PLAN SHOWING PROPOSED BUILDING TO BE

BUILT ON PLOT NO 58/1 J. L. 6.

JAIL QUARTER

Re: Plot No 58, J.G.B. Jail QuarterWith reference to your letter of 17th inst the plans have been modified as follows:—

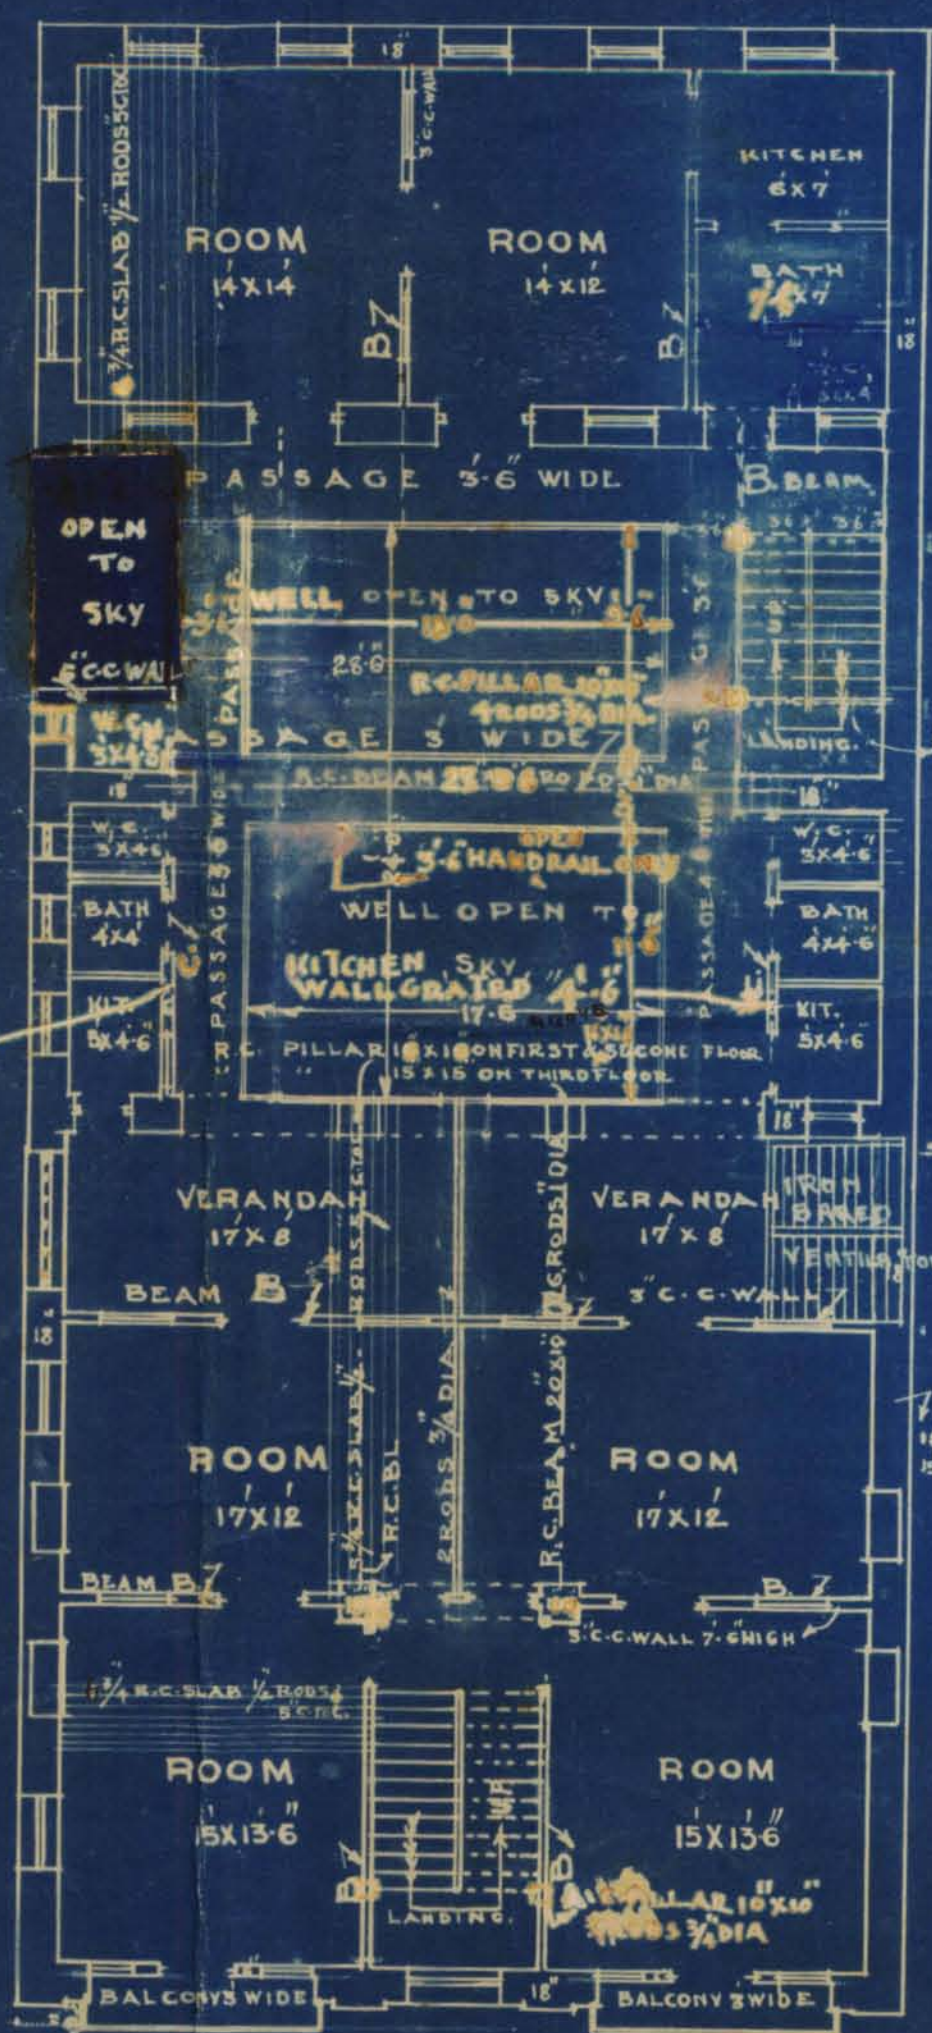
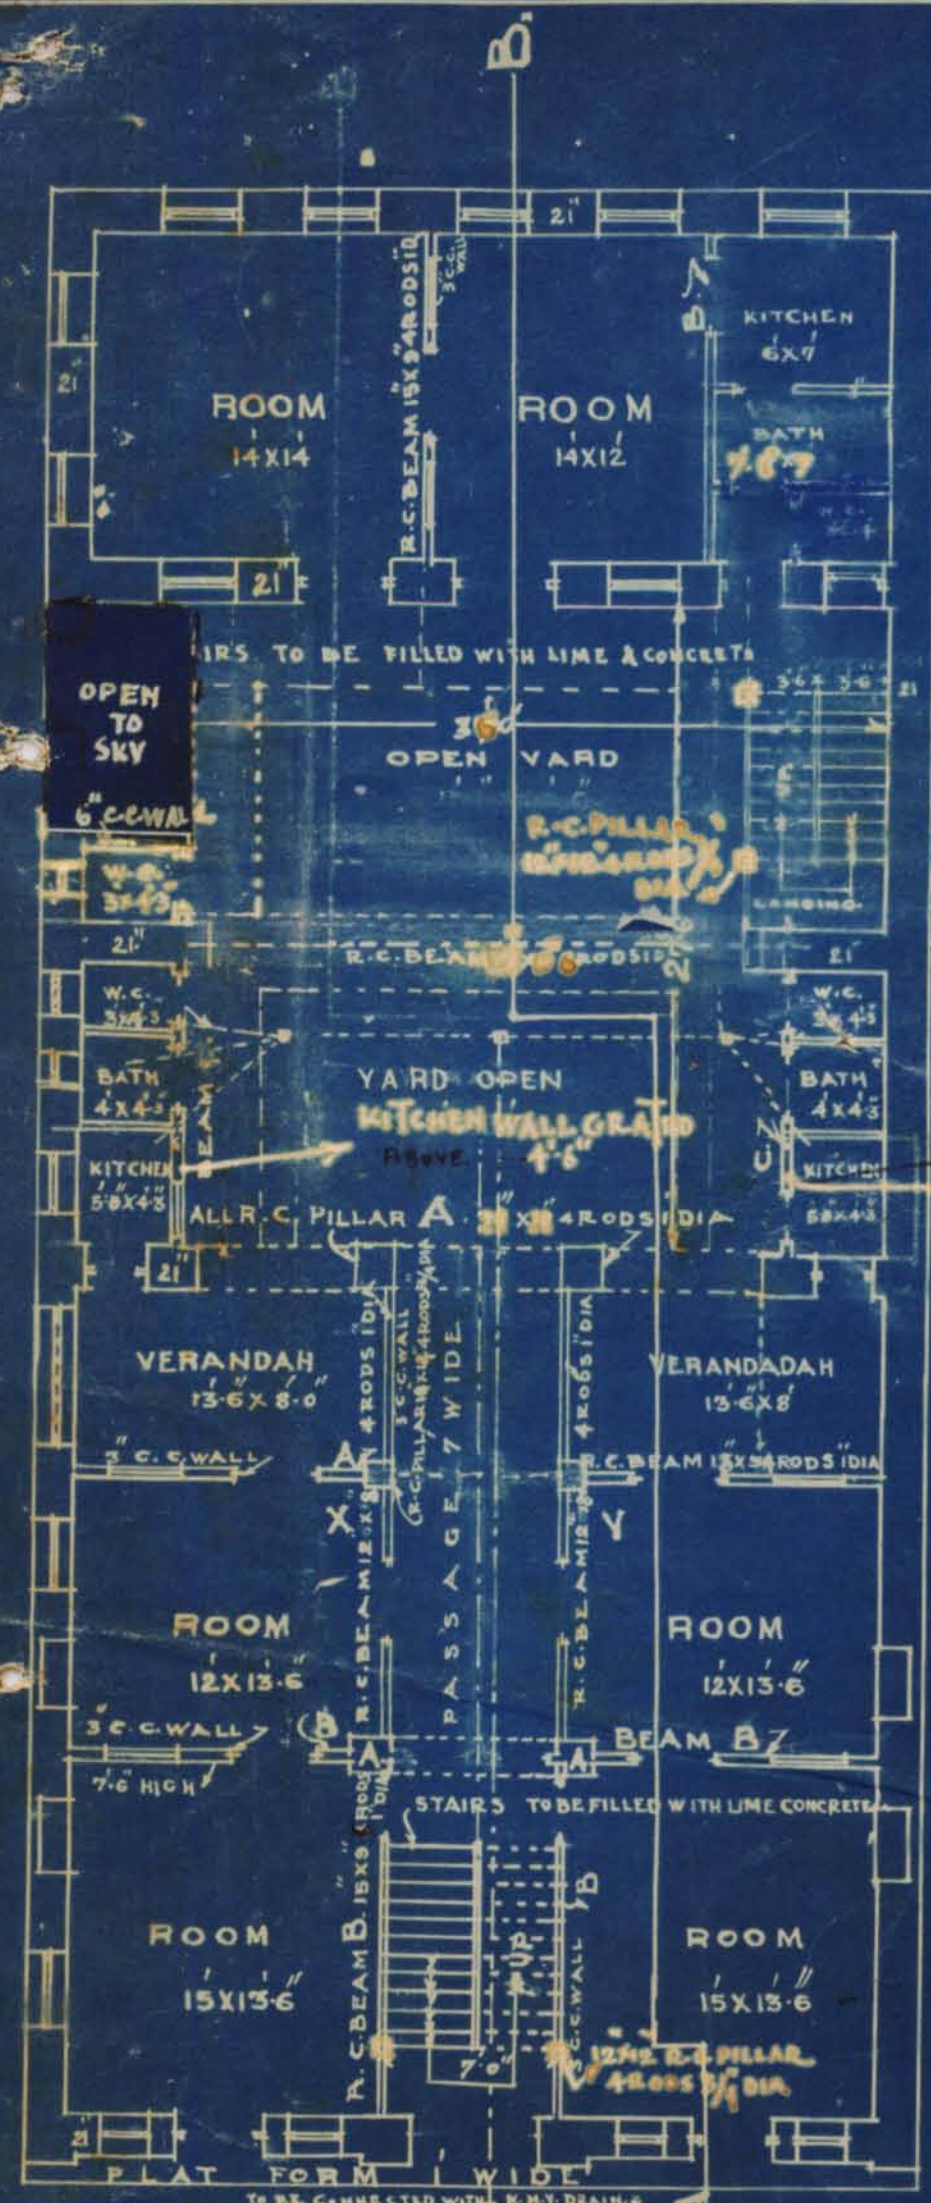
In future
plans with
central
rooms will
not be
considered.
22/4/30

C
P. attach for
22/4.Submitted the
architect has removed
all objections
approved
22/4.The plans may now be
P.S. Pathak
22/4
Please note the
architect why he
has not shown
the 14' span as
originally
proposed
22/4

- note at the rear rear staircase is against Bye-laws.*
- (1) *Masonry one side of central room does not abut on internal or external open space throughout its length.*
 - (2) *The plan requires touching up.*
 - (3) *Widths of open spaces free from galleries & other obstructions be marked on plans.*
 - (4) *5 3/4" slab would not do for a 14' span. A beam be provided in the centre.*
 - (5) *Kitchen & bath room walls require extra rods & beam 15" x 9" must have 1 rod extra.*
 - (6) *Posts are necessary for the R.C. stair. They must be shown.*
 - (7) *Columns to be 21" x 21" on ground floor, 18" x 18" on 1st floor, 16" x 16" on 2nd floor & 15" x 15" on top floor.*
 - (8) *The beam for 23' span must be 23" x 10" with 6 rods 1" diam.*
 - (9) *The 3rd passage shall have only 3'-6" open hand rails only.*

- ① The Plans require trucking up
 - ② Width of the spaces from from galleries rather than obstructions be marked on the
 - ③ $5\frac{3}{4}$ slab would do for a 14' span Why does the architect let Parson's a beam in the center
 - ④ Bells & bats room walls require sheathing & beam 15×8 ' will have where I rods ending
 - ⑤ Posts are heavy in the R.C. stair they must show 21×21 up the
 - ⑥ Pillar 12×18 ' or 18×18 ' or 16×16 ' or
 - ⑦ The legs 2×2 for 23 ' span make 15×15 ' a top floor
 - ⑧ The 3' Parage shall have 22×10 ' with 6 rods $3-6$ rods rails only
- 9/4

- (1) The position of w.c. is changed as suggested by you.
- (2) The plan is touched up.
- (3) The width of open spaces are shown as required.
- (4) The thickness of 14' span slab is made 6 3/4" & so no separate beam is provided.
- (5) The beam 15' x 9" has been given 1 extra rod 1" dia.
- (6) The R.C. Pillars are made as required.
- (7) The beam 23' span is given one rod extra of 1" dia.
- (8) The 3' passage is only provided with 3' of 1" dia.

PLAN SHOWING PROPOSED BUILDING TO BE
BUILT ON PLOT NO. 58/1 J.L.6.
JAIL QUARTER
SCALE 8"=1'

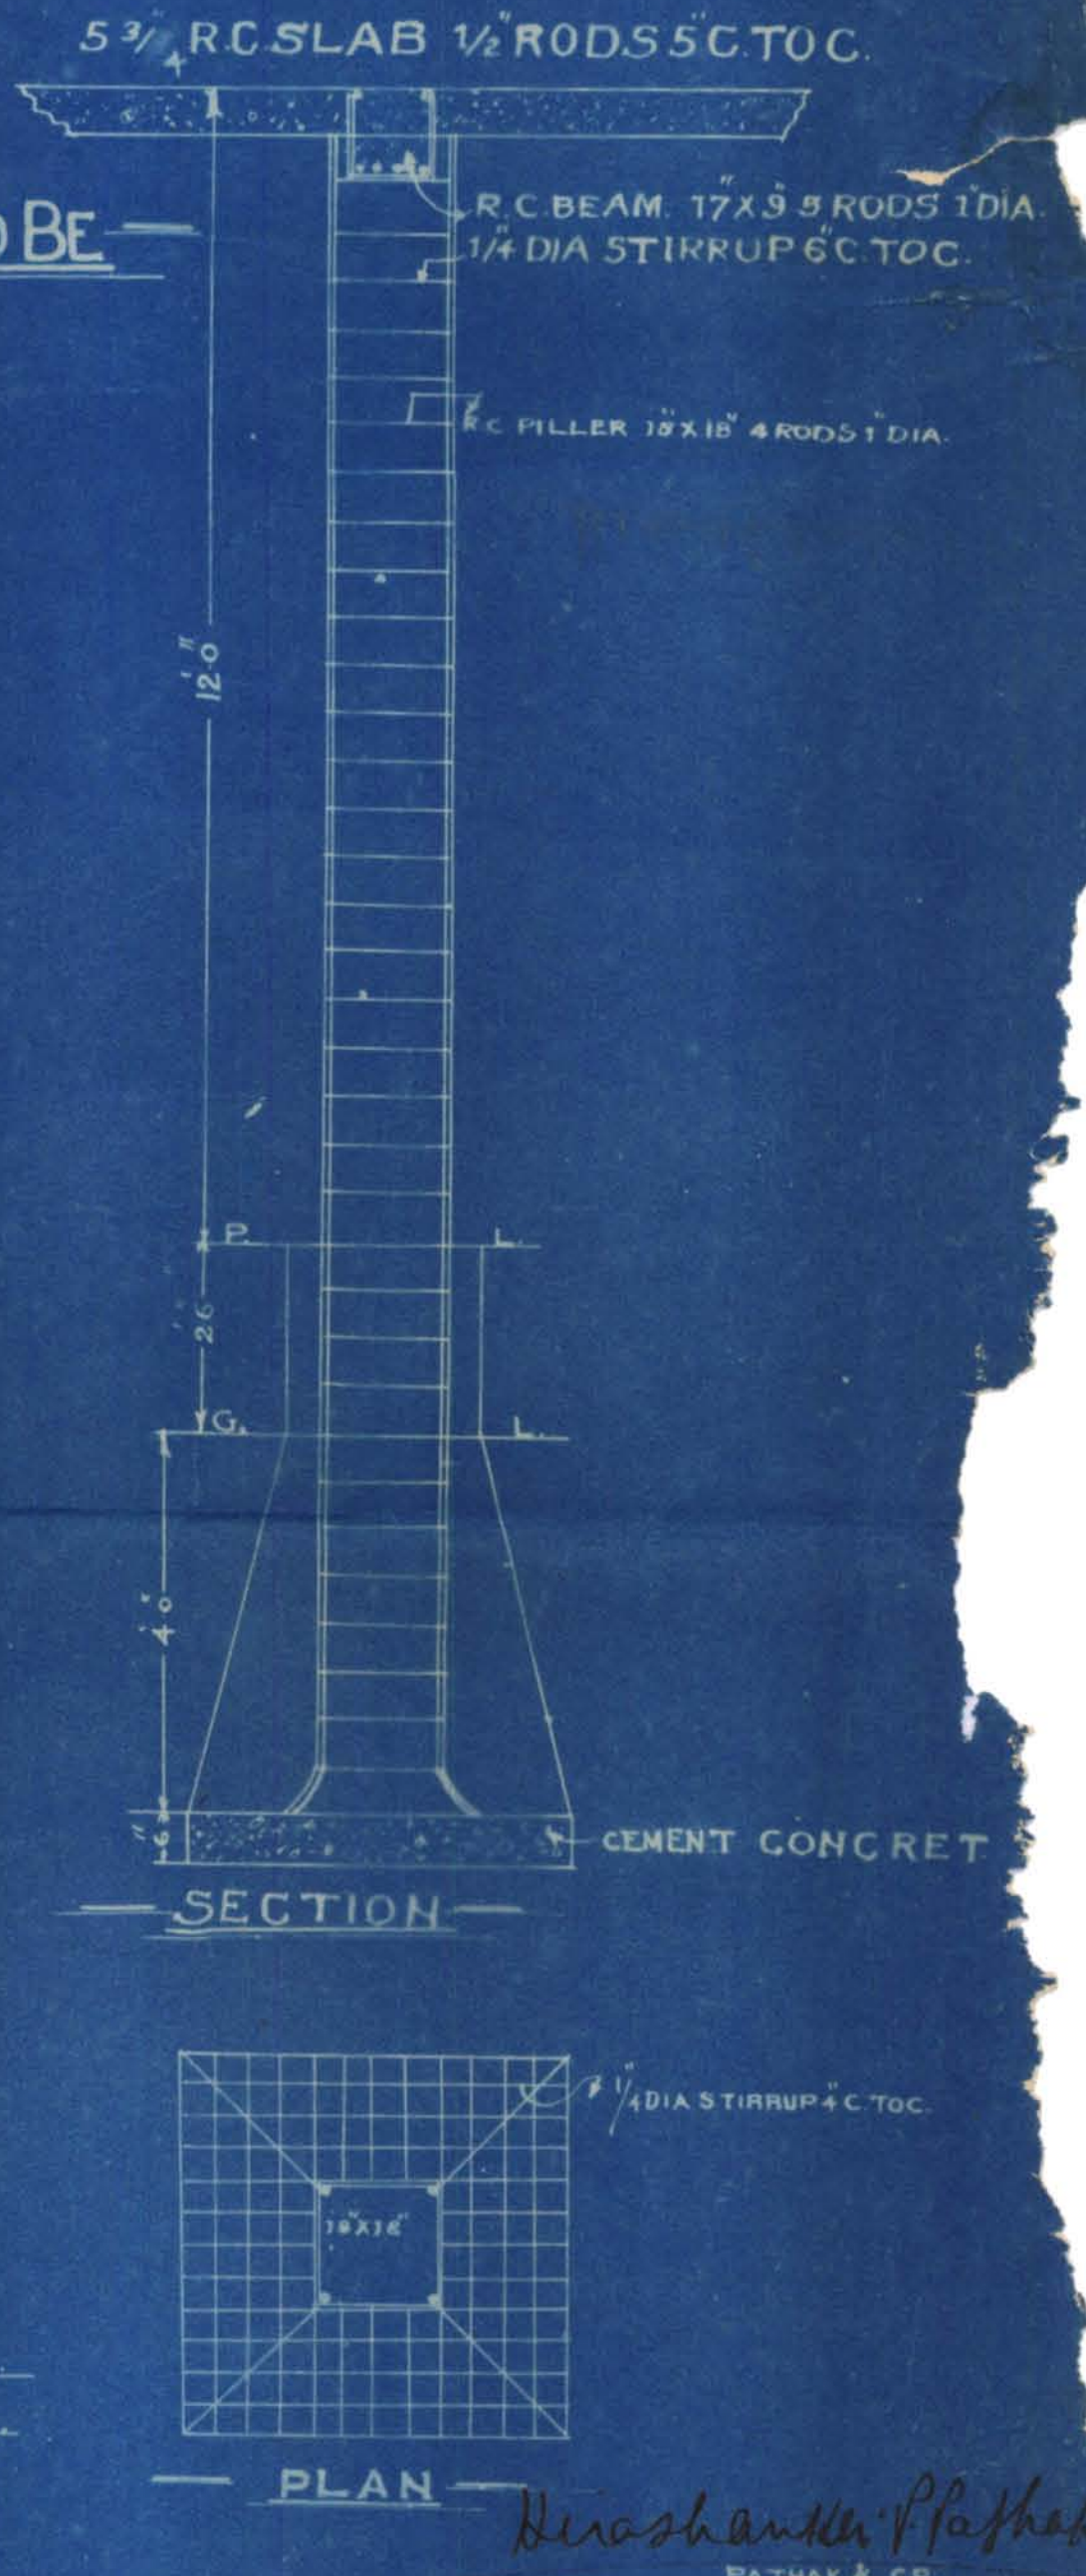
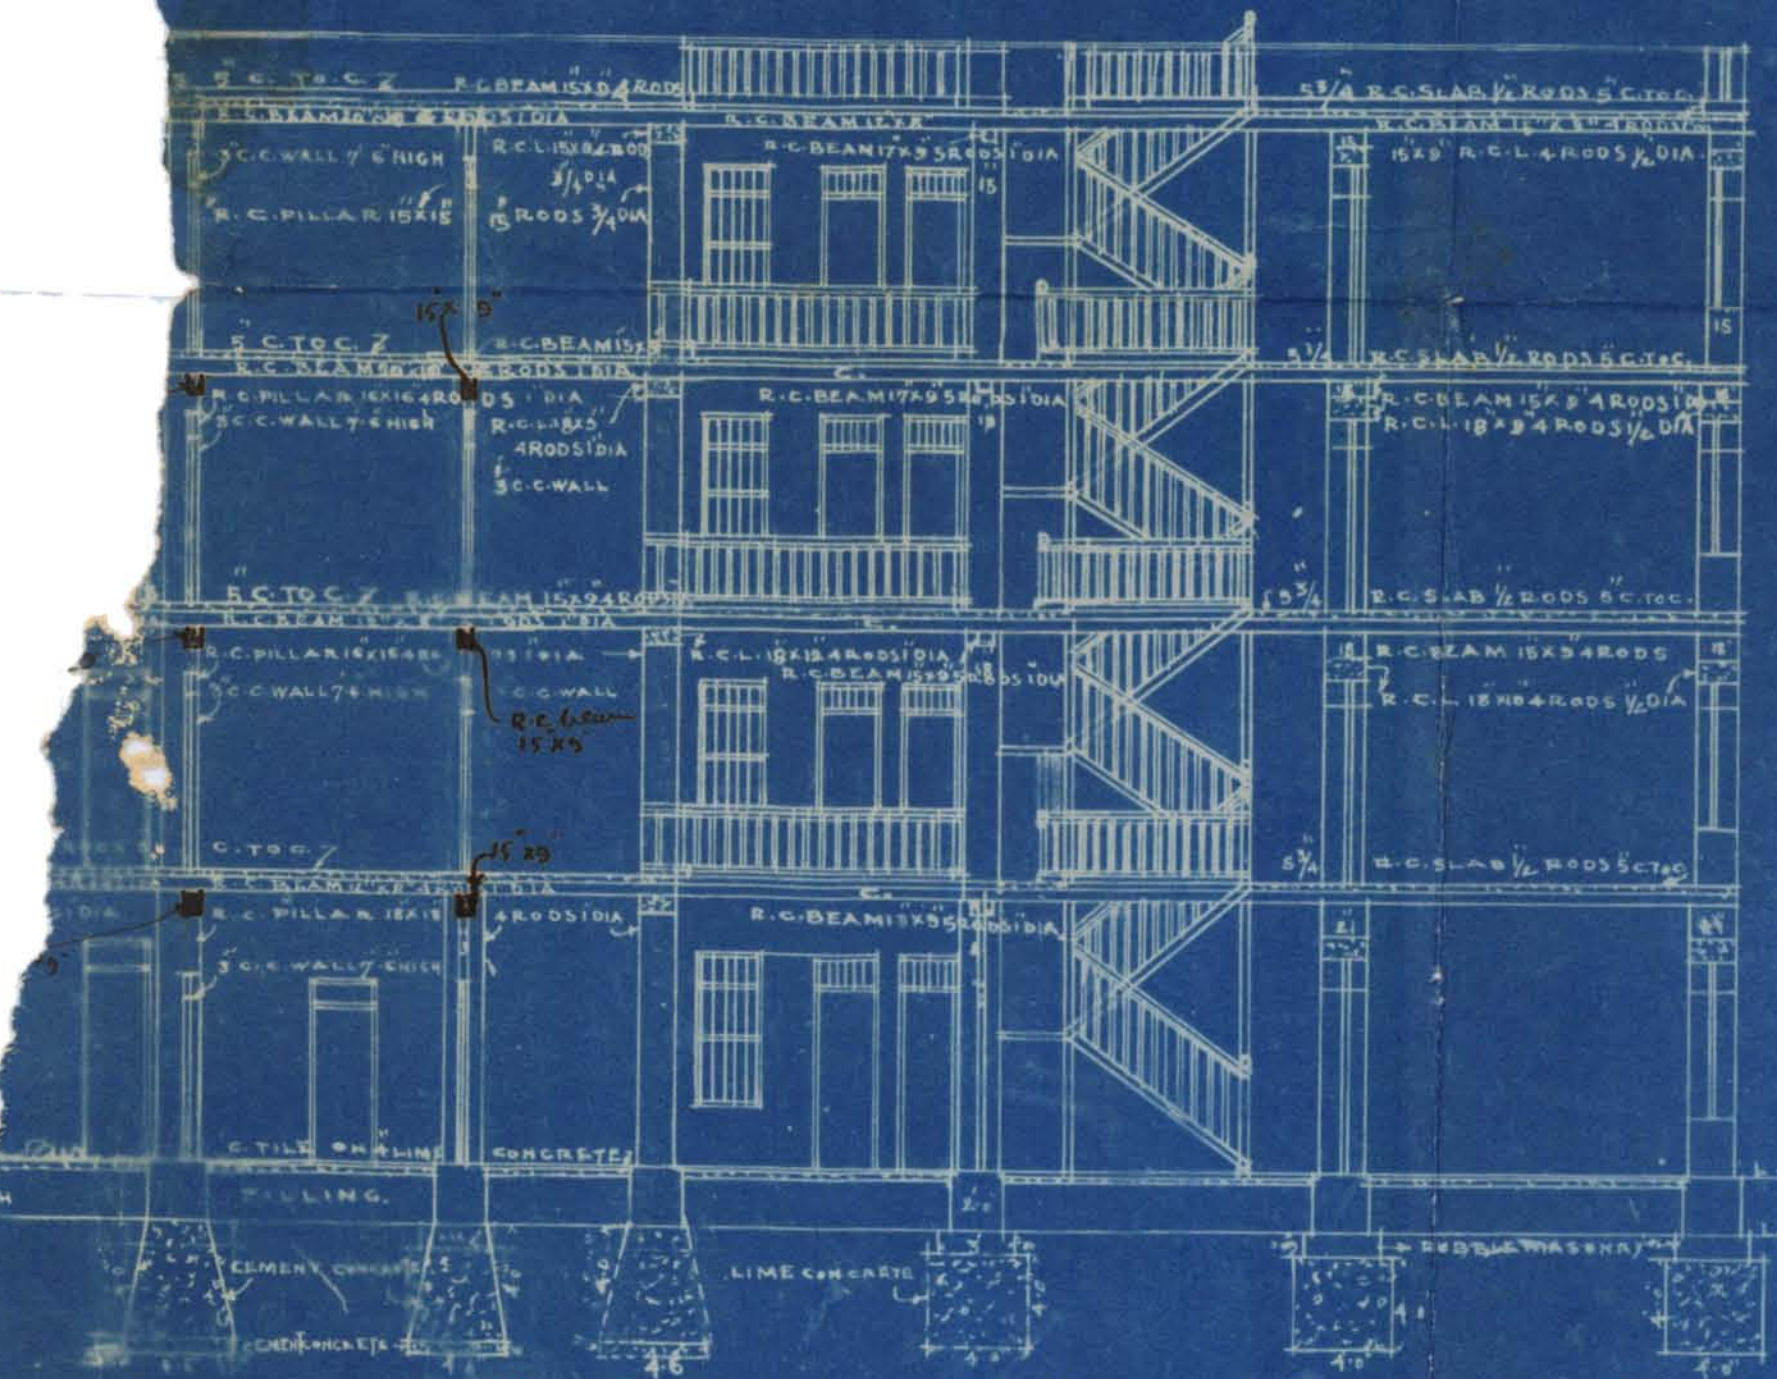
H.O. writes *No objection to amendment* (1) Central rooms will be quite dark.

✓ (2) The existing structure must be demolished.

✓ (3) The intermediate R.C.C pillars should of the same size as the end ones.

✓ (4) At the bottom of foundations near the grillage the 6" concrete must be ^{cement} connected. Bldg. must be shown

✓ (5) in the site or block plan to show that the gully or lane is kept over which windows are proposed.

(6) The rear rooms A-B do not get proper air & light.

{ (7) The Place is overcrowded & plan cannot be passed.

✓ (8) Why the R.C. beams, R.C. columns are not shown in Section?

Area supported by pillar

$$\begin{aligned} 7'6" + 9'6" &= 17' \times 8'3" \\ &= 140.25 \text{ sq. feet.} \end{aligned}$$

$$\begin{aligned} \text{wt. of slab} &= 140.25 \times 75 \\ &= 10500 \text{ lbs. say.} \end{aligned}$$

$$\text{wt. of partition} = 10700 \text{ "}$$

$$\text{wt. of Beams} = 2000 \text{ "}$$

$$\text{Total} = 23200$$

Strength of pillar $15" \times 15"$ with 4 rods $1"$ dia.

$$\begin{aligned} &500 (15 \times 15 + 14 \times 3.14) \\ &= 500 \times 269 \end{aligned}$$

$$= 134500 \text{ lbs.}$$

load on ground floor column.

$$23200 \times 4 = 92800 \text{ lbs.}$$

Strength of $18" \times 18"$ column. 4 " rods $1"$ dia.

$$184000 \text{ lbs.}$$

The central rooms get light from the front as well as from the back as the partitions are $7\frac{1}{2}$ feet high between 1st and 2nd rooms and on the hind side there is open verandah.

The existing structure will be demolished.

The intermediate Columns ^{x & y} are sufficient in size as they support only the floor load from the 1st floor. The strength of the column is more than that ^{required for the load} it can ever be called upon to bear ^{as} ~~still~~ they are made ^{now} 14" x 14".

The 6" cement concrete at the base of the column will be provided. The lime concrete was written by some mistake

The rear rooms A & B. as referred by you do get sufficient light, if not ^{more} proper, as the windows on the rear and open space in front are provided.

The R.C.C. columns and beams ^{are now} were already shown in section with details of reinforcement.
